Village of Arlington Heights
Plan Commission
Virtual Hearing
June 10, 2020
7:30 PM

- A. Vasa Fitness - 750 E. Rand Rd. - PC#20-002
PUD Amendment to Ord. 90-014, Variation

RE: DPS AUTOMOTIVE - 855 WEST UNIVERSITY DRIVE - PC# 20-007
LAND USE VARIATION

LANDSCAPE PLAN

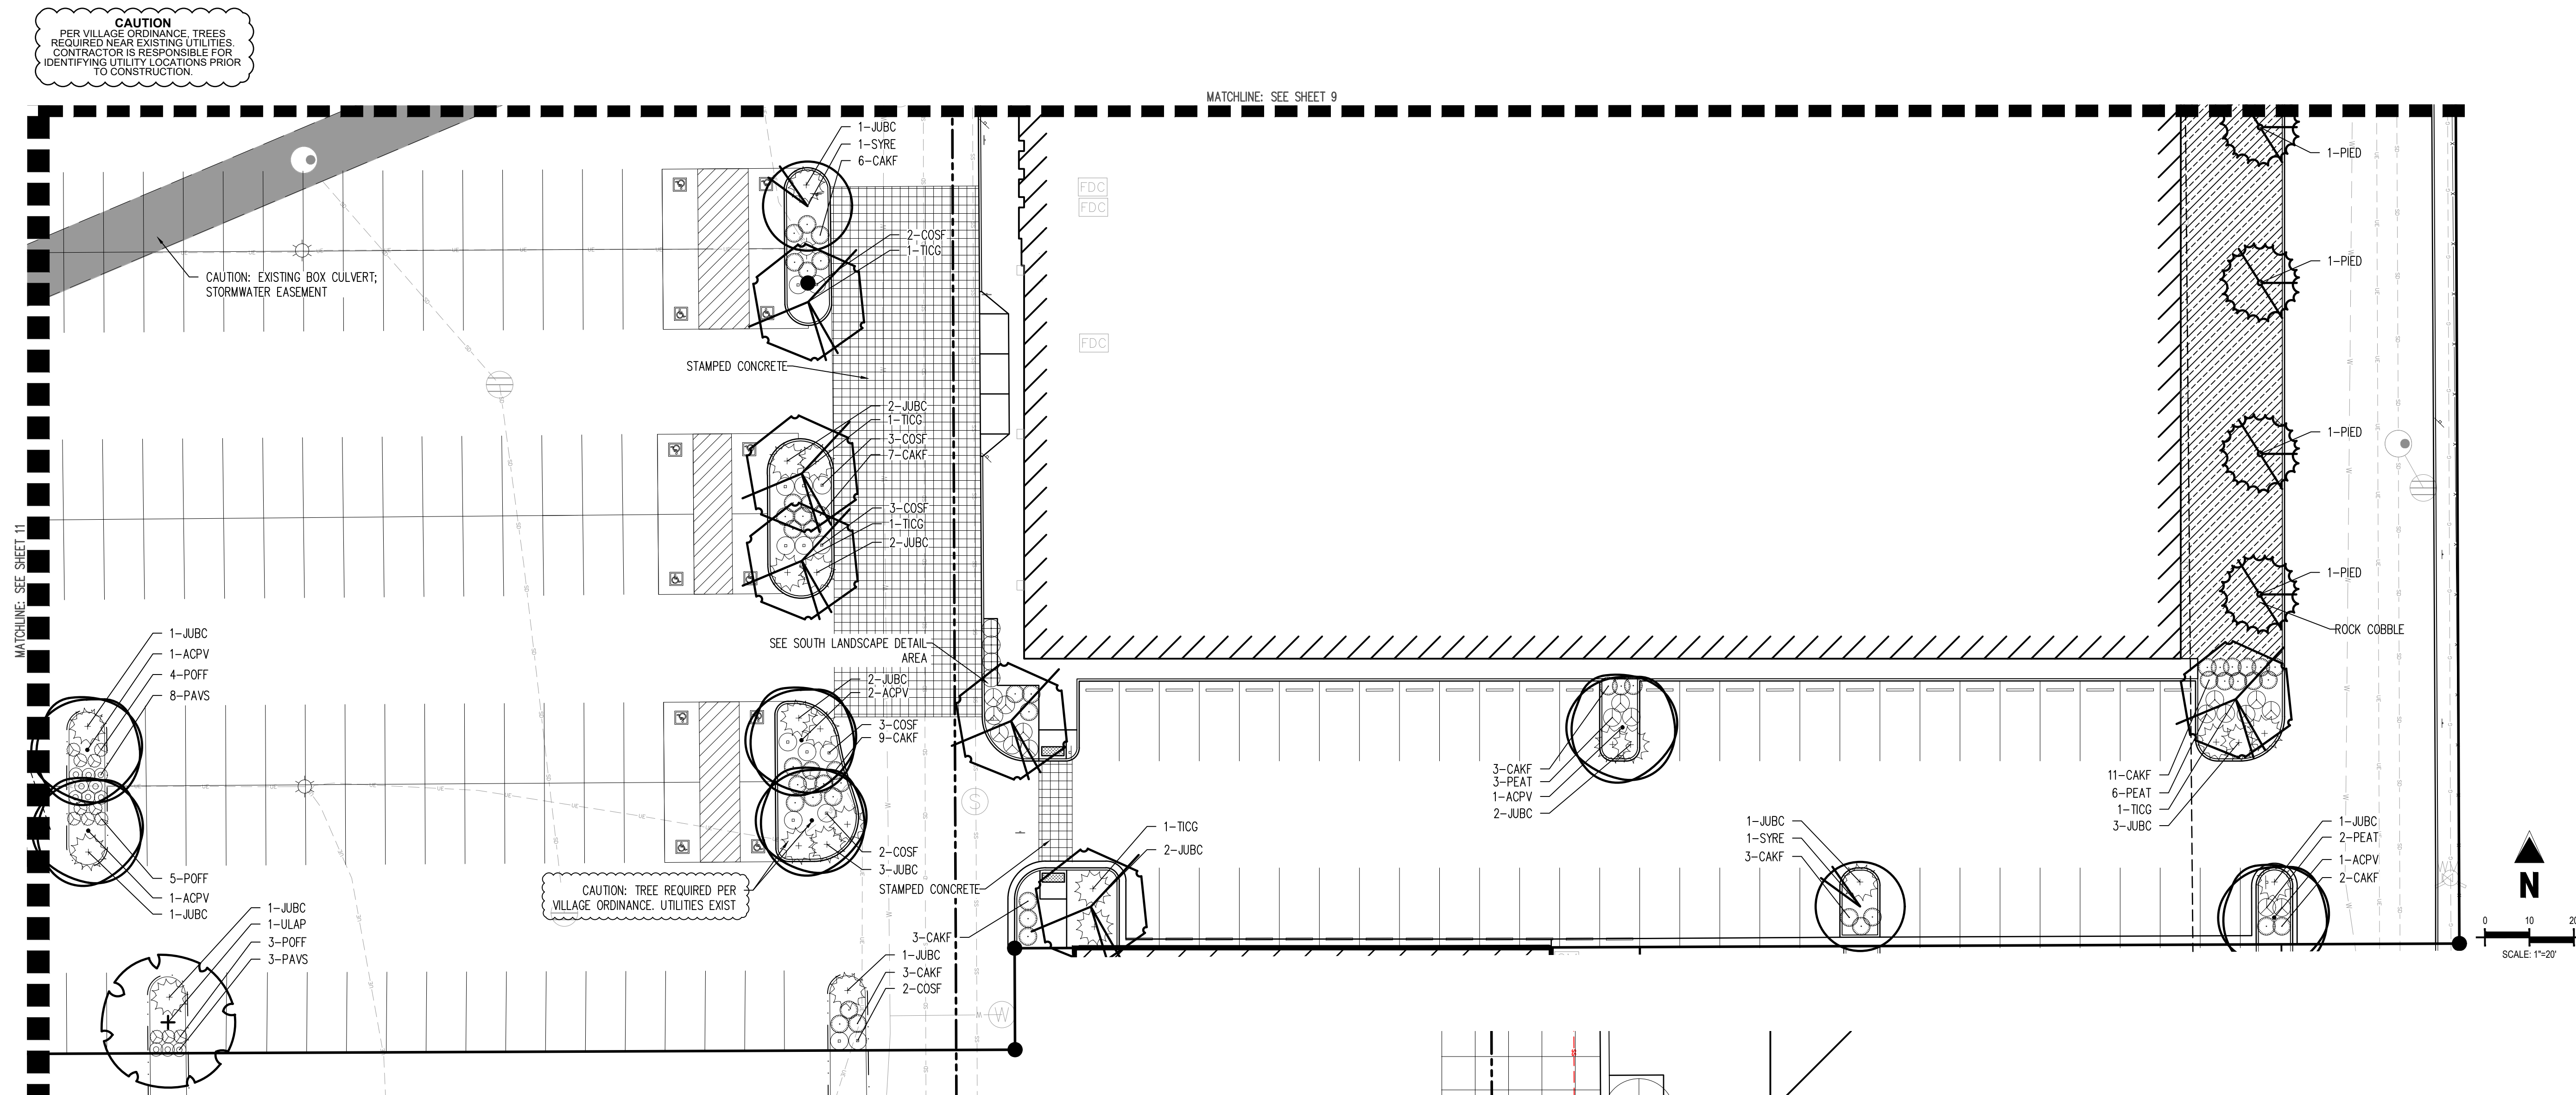
- 2) As part of the plant legend, please include all plant material. It was noted that some of the plant material was not listed on sheet 10. In addition, please identify all plant material on the planting plan.

24. The scale for the "Northern Landscape Area" on sheet 10 does not appear to be accurate. Please correct.

- 2) As part of the plant legend, please include all plant material. It was noted that some of the plant material was not listed on sheet 10. In addition, please identify all plant material on the planting plan.
The revisions are noted.

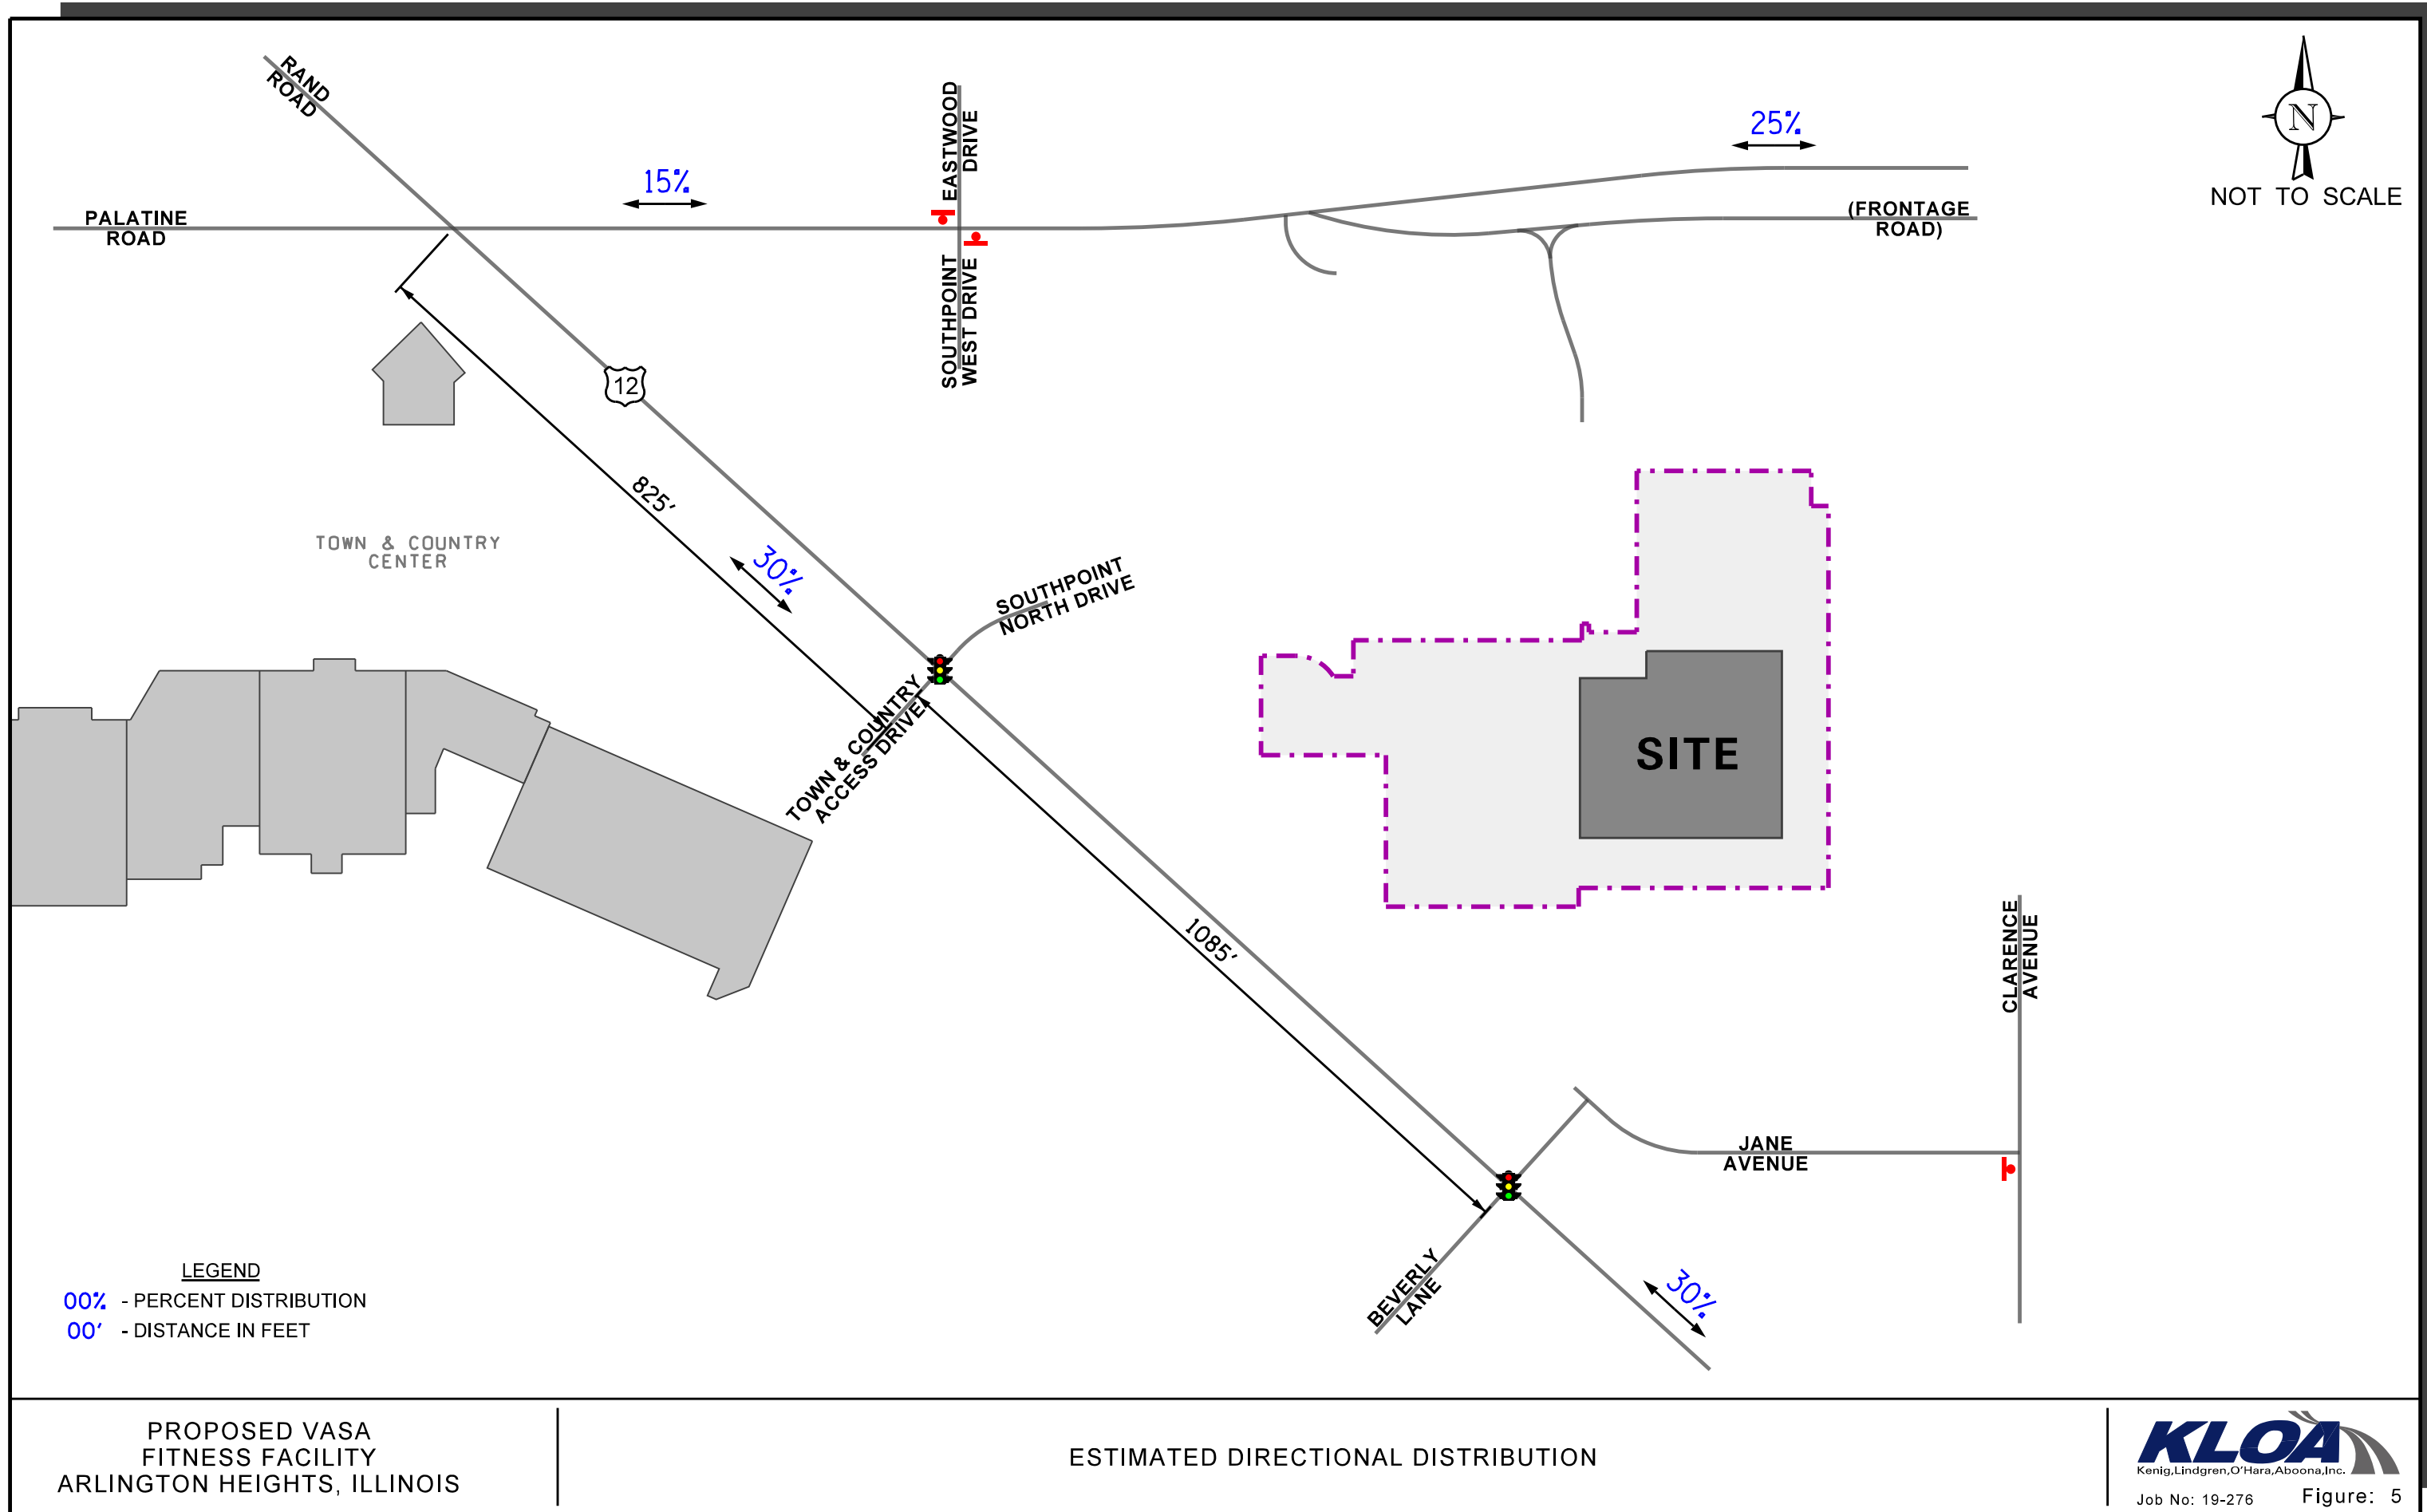
38. (Traffic Report, Page 8) Provide ITE Trip Generation excerpts for values obtained in Table 1.
39. (Traffic Report, Figure 5) The intersection of Rand/Beverly/Jane provides direct access to site. Although existing traffic counts show low northeast-bound traffic, this may be a misrepresentation of how traffic would operate in the future due to current vacancies in the Southpoint Shopping Center. Provide justification for the assumption that no site traffic will enter from northeast-bound Beverly Lane.

39. (Traffic Report, Figure 5) The intersection of Rand/Beverly/Jane provides direct access to site. Although existing traffic counts show low northeast-bound traffic, this may be a misrepresentation of how traffic would operate in the future due to current vacancies in the Southpoint Shopping Center. Provide justification for the assumption that no site traffic will enter from northeast-bound Beverly Lane.

Figure: 6

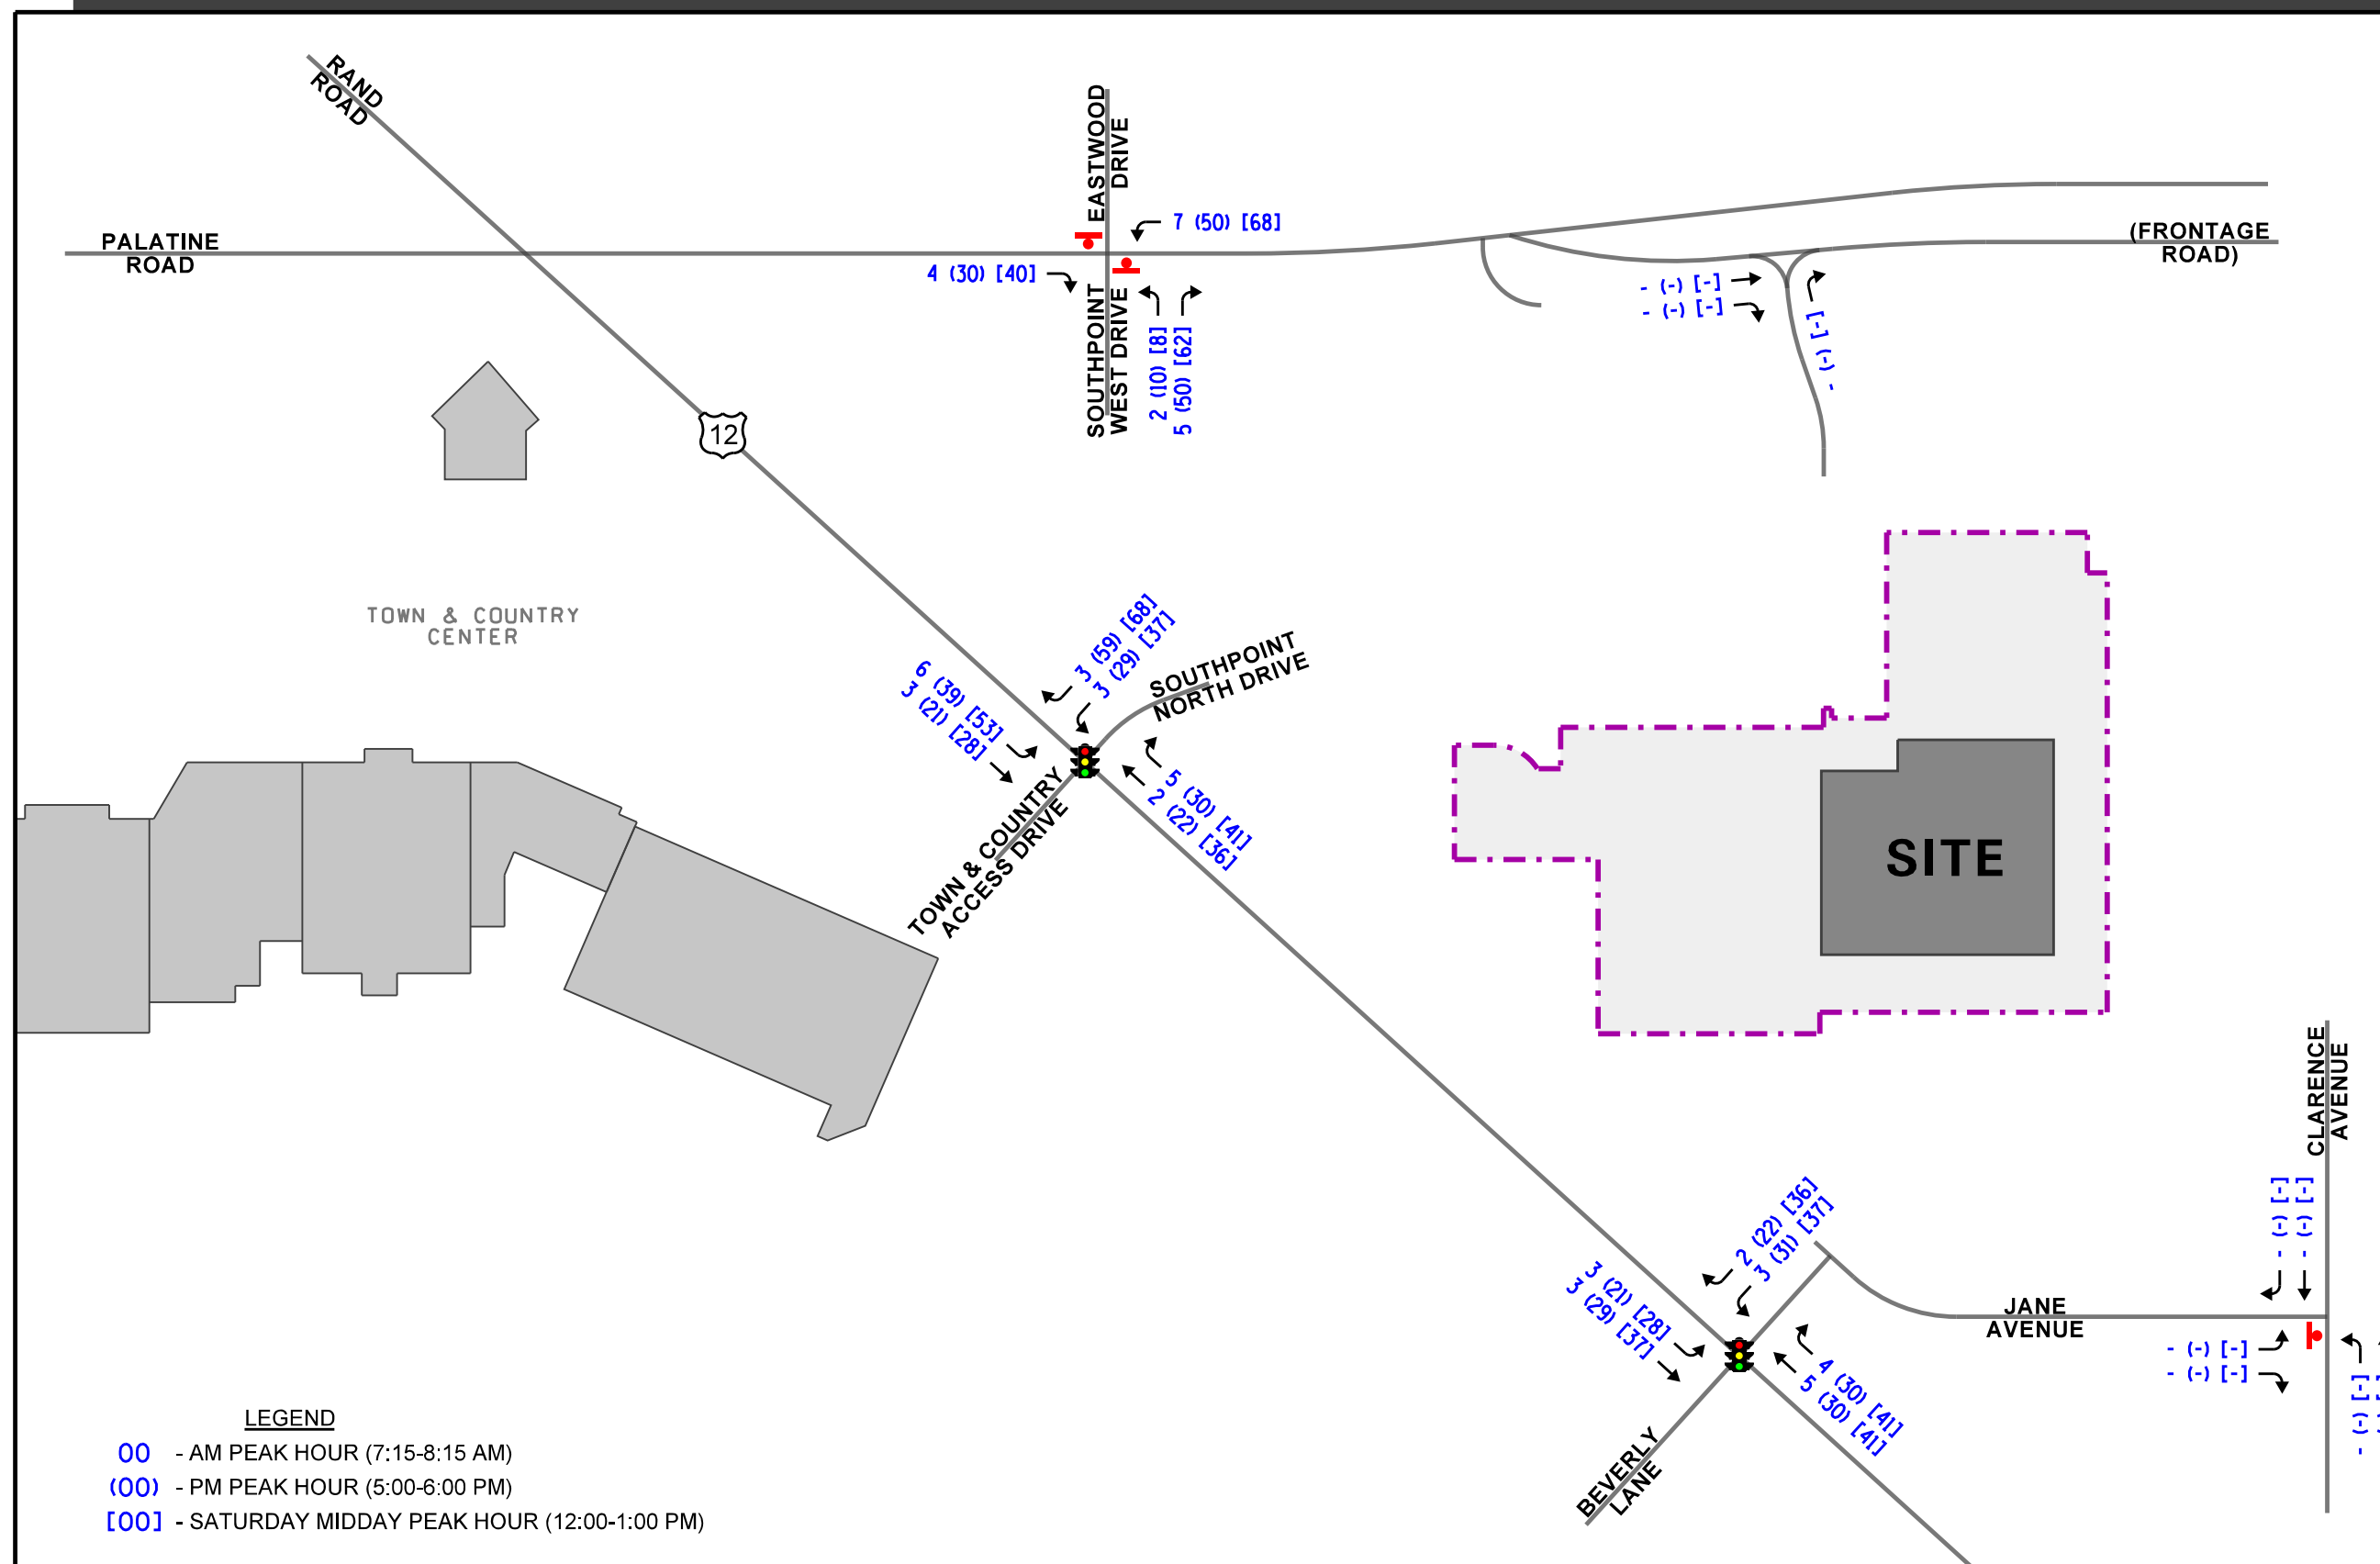
40. (Traffic Report, Figure 7) Provide ITE Trip Generation excerpts used for values obtained in Figure 7. How was directional distribution determined for these future developments?

40. (Traffic Report, Figure 7) Provide ITE Trip Generation excerpts used for values obtained in Figure 7. How was directional distribution determined for these future developments?

Response: Noted. Please see the trip generation table for these vacancies and the enclosed ITE Trip Generation Graphs in the Appendix of the revised traffic impact study. The internal directional distribution was generally determined by the location of the vacant spaces in relation to the existing access drives and the estimated directional distribution shown in Figure 5.
